**LIST OF FIELD MODIFICATIONS**

**WASP 985 AN-5, -14B ENGINES**

(This EO replaces EO 10A-10AA-6A dated 13 Nov 63)

Figure 1 (Issue 3)

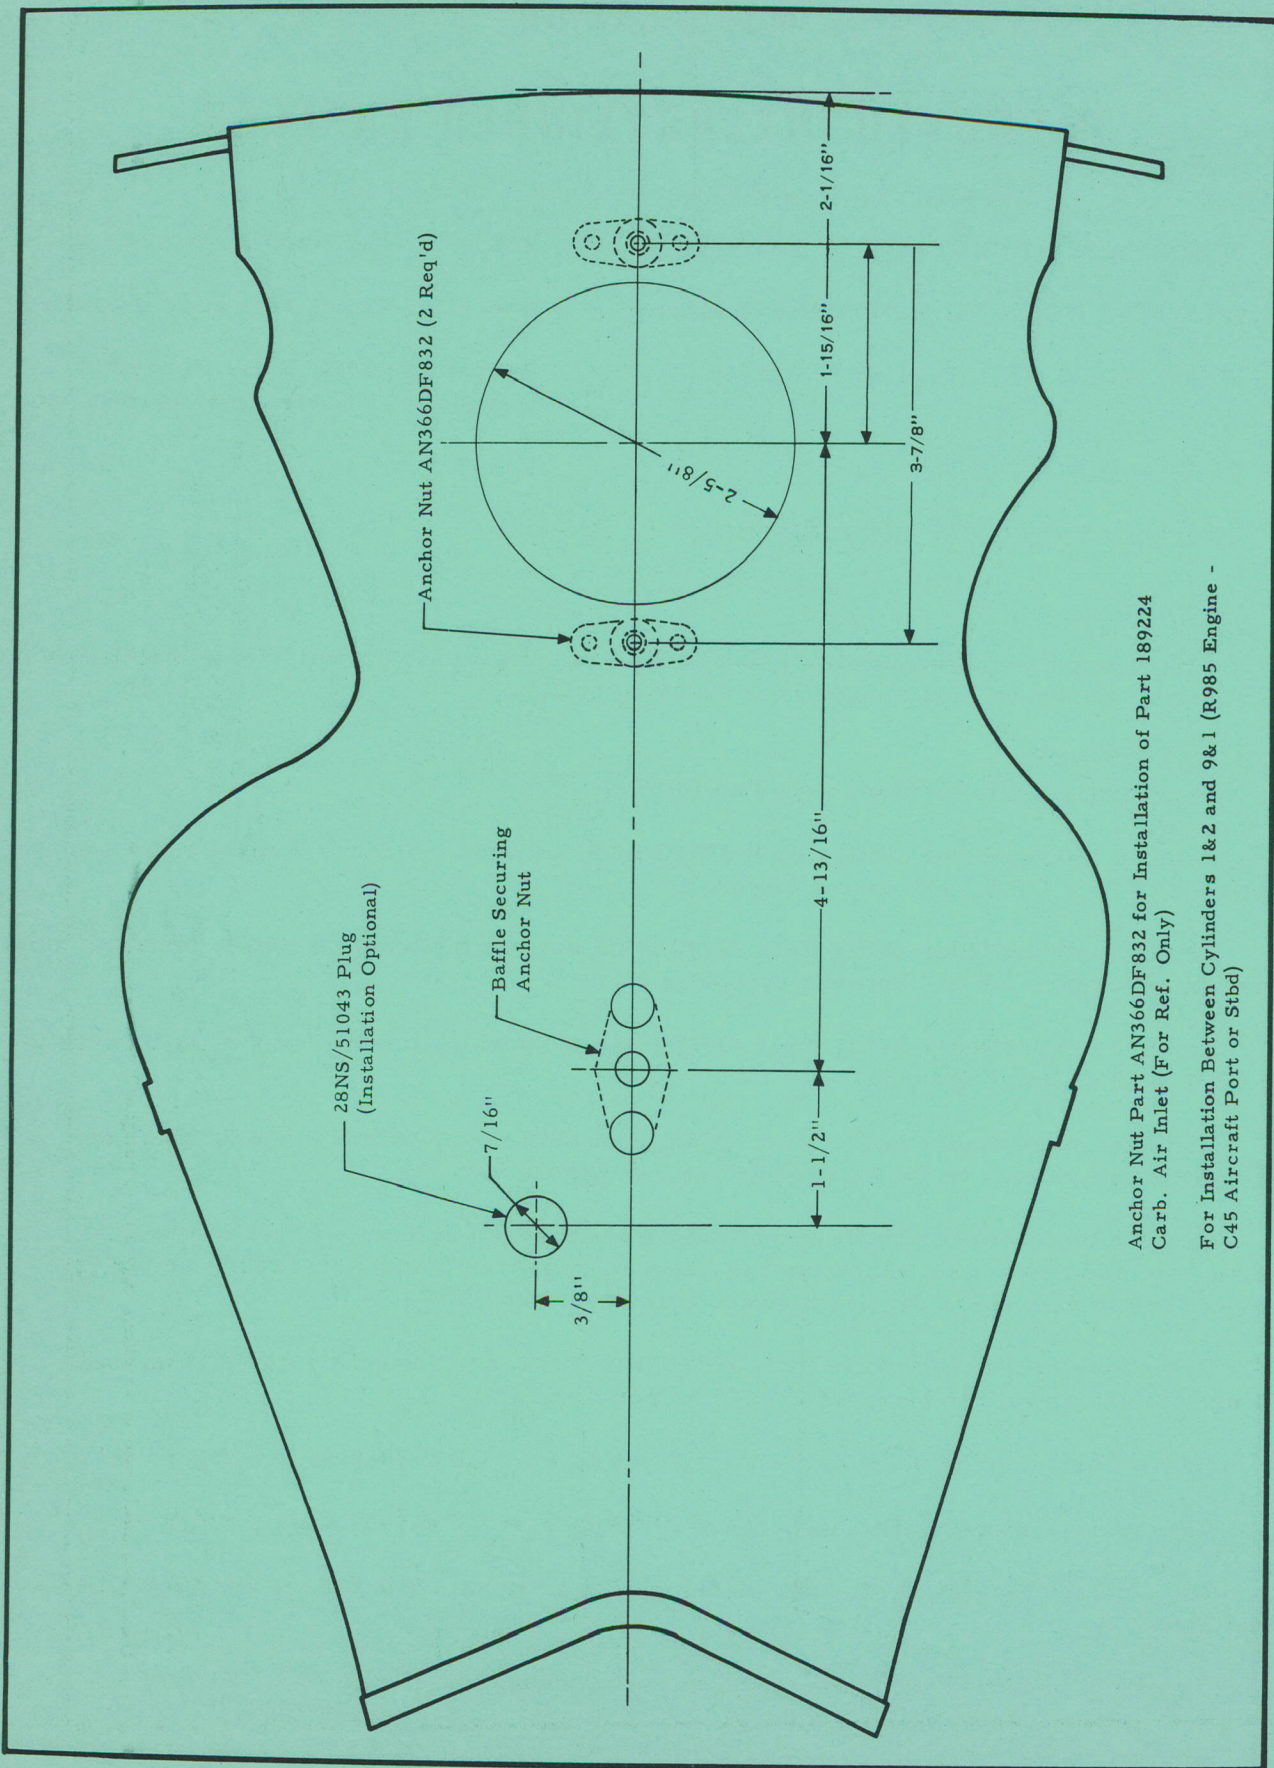
- (a) Remove intercylinder baffles Part 39982 from between cylinders 9 and 1 and 4 and 5 and rework to Part CPW 9437 as per Figure 1.
- (b) Remove intercylinder baffle Part 39990 from between cylinders 1 and 2, blank off hole and retain as a spare for use between cylinders 6 and 7.

Anchor Nut Part AN366DF832 for Installation of Part 189224  
Carb. Air Inlet (For Ref. Only)  
For Installation Between Cylinders 1&2 and 9&1 (R985 Engine -  
C45 Aircraft Port or Stbd)

Figure 2

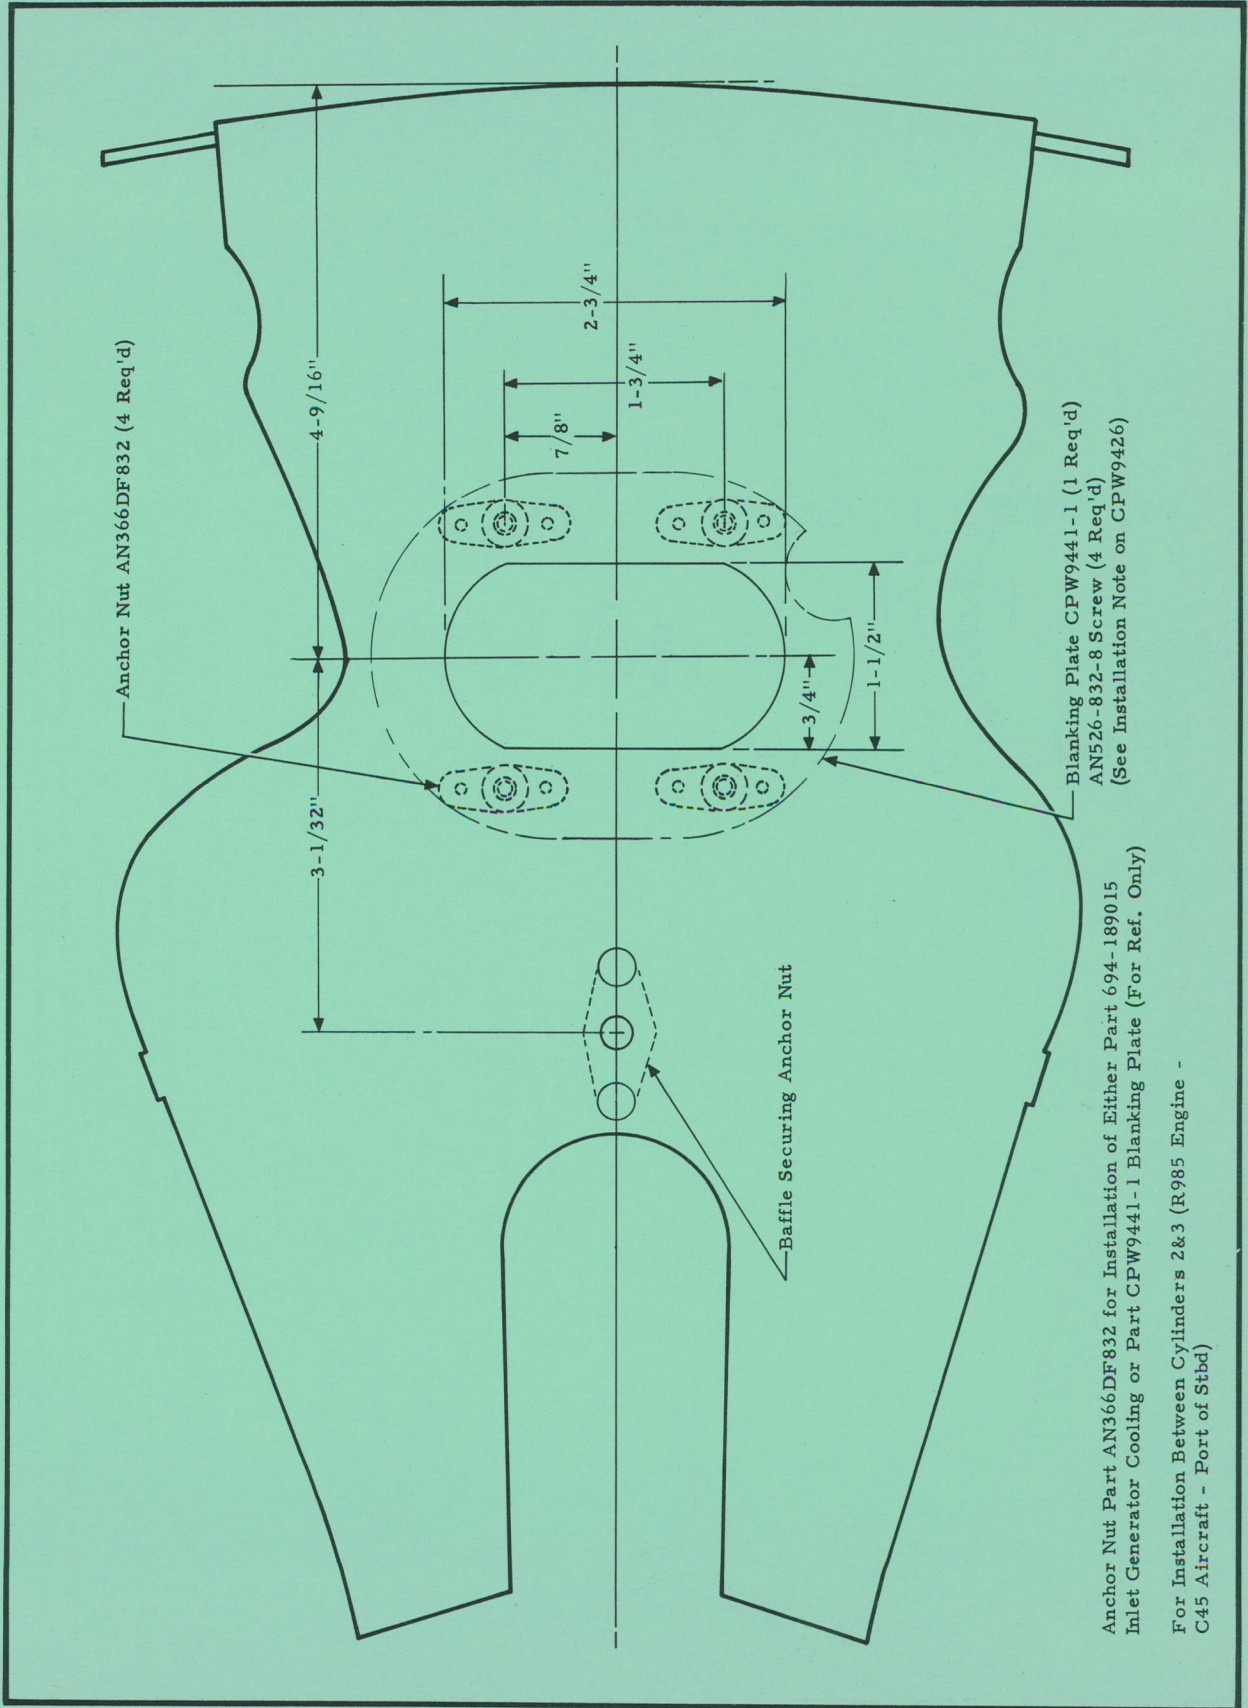
- (c) Remove intercylinder baffle Part 39988 from between cylinders 2 and 3 and rework to Part CPW 9438 as per Figure 2.
- (d) Remove intercylinder baffle Part 39986 from between cylinders 8 and 9, blank off existing hole and rework to Part CPW 9442 as per Figure 5.

Figure 3

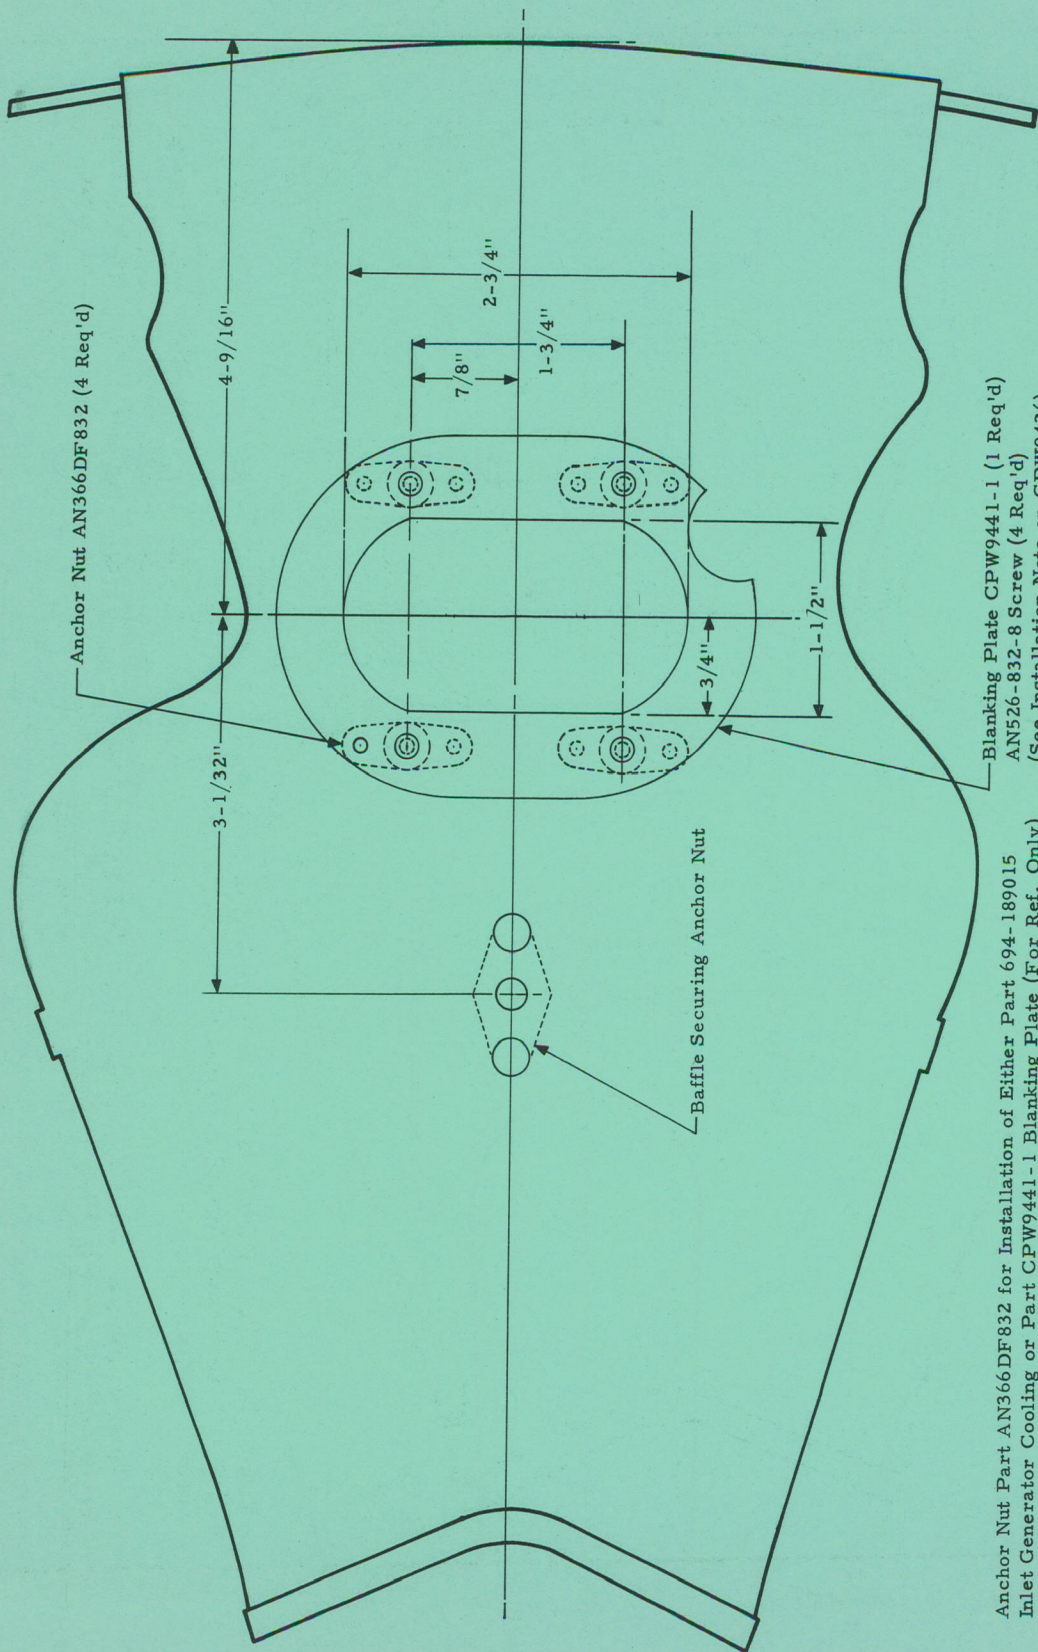
- (h) Rework new intercylinder baffle Part 39982 to Part CPW 9439 as per Figure 3.
- (j) Manufacture locally, 1 of each, blanking plates, Parts CPW 9441-1 and CPW 9441-2 as per Figure 6.

Anchor Nut Part AN366DF832 for Installation of Either Part 694-189015  
Inlet Generator Cooling or Part CPW9441-1 Blanking Plate (For Ref. Only)  
For Installation Between Cylinders 8&9 (R985 Engine -  
C45 Aircraft - Port or Stbd)

Figure 4 (Issue 3)

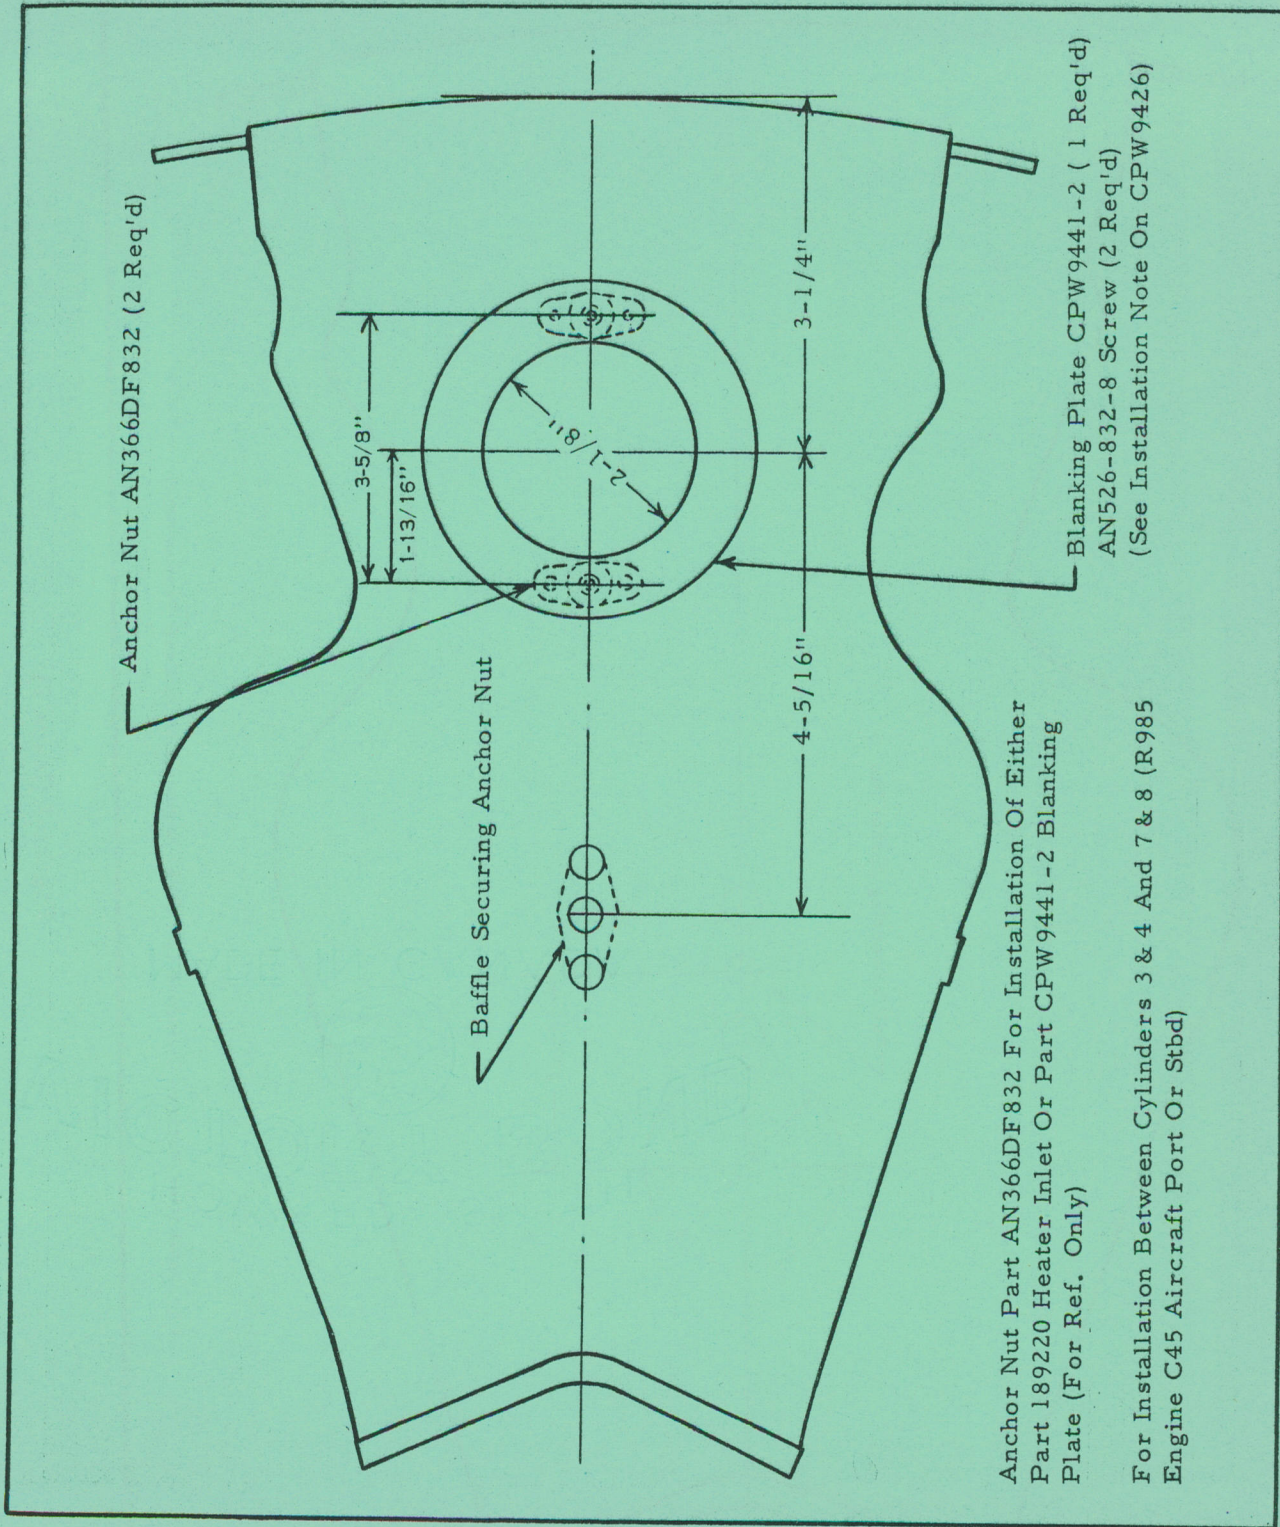
- (f) Remove intercylinder baffle Part 39992 from between cylinders 7 and 8, blank off existing hole and rework to Part CPW 9440 as per Figure 4.
- (g) Rework new intercylinder baffle Part 39986 to Part CPW 9440 as per Figure 4.
